From: David Weber <dweber@wearehls.com>
Sent: Thursday, June 18, 2020 6:00 PM
To: Wooldridge, John; Norton, Harvey
Cc: Heim, Kimber
Subject: RE: 110412 FAI 037 Safety Project D5 Requests Signed Appraisal Checklists

Subject: RE: FAI-37-6.34 Preliminary Right of Way Plans (PID No. 110412)

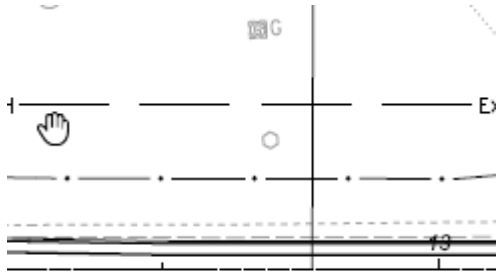
- Missing sheet 20 of 37 as Luke stated.
- Page 21/36 (22/37) Parcel 11-SH shows "Utility Pole Save" for private light poles. I would have them removed as ODOT will need to pay for them anyways (in take area) and would need to do a permit (not recommended) for the poles that are very close to the fence needing removed. Same Parcel has three of those poles (not 2) and also has a small sign near the fence that was not picked up on these plans:

- Page 23/36 (24/37) Can Parcel 12-SH be completely removed? The Construction limits are almost all out of the take and the ditch is in the Ex R/W. Could save some money having one less parcel.
- Page 25/36 (26/37) 14 no take, Please mark encroachment of a singular post:

- PG 31/36 (32/37) We may have future comments about the water building. Pending Village of Thurston review comments. Latest email by Utilities is attached.
- PG 31/36 (32/37) PCL 9 No Take has encroachments to mark for removal (2 of the 3 signs ... last one shown as "save" not in R/W):

- Several pages: “edge of farm field ... SAVE” within R/W is shown; I do not recommend saving that as it will not be permitted and construction company should be able to use all the R/W existing at their discretion. We typically do not label it either save nor remove.
- Legal descriptions were not provided to me and therefore not reviewed against these R/W Plans.
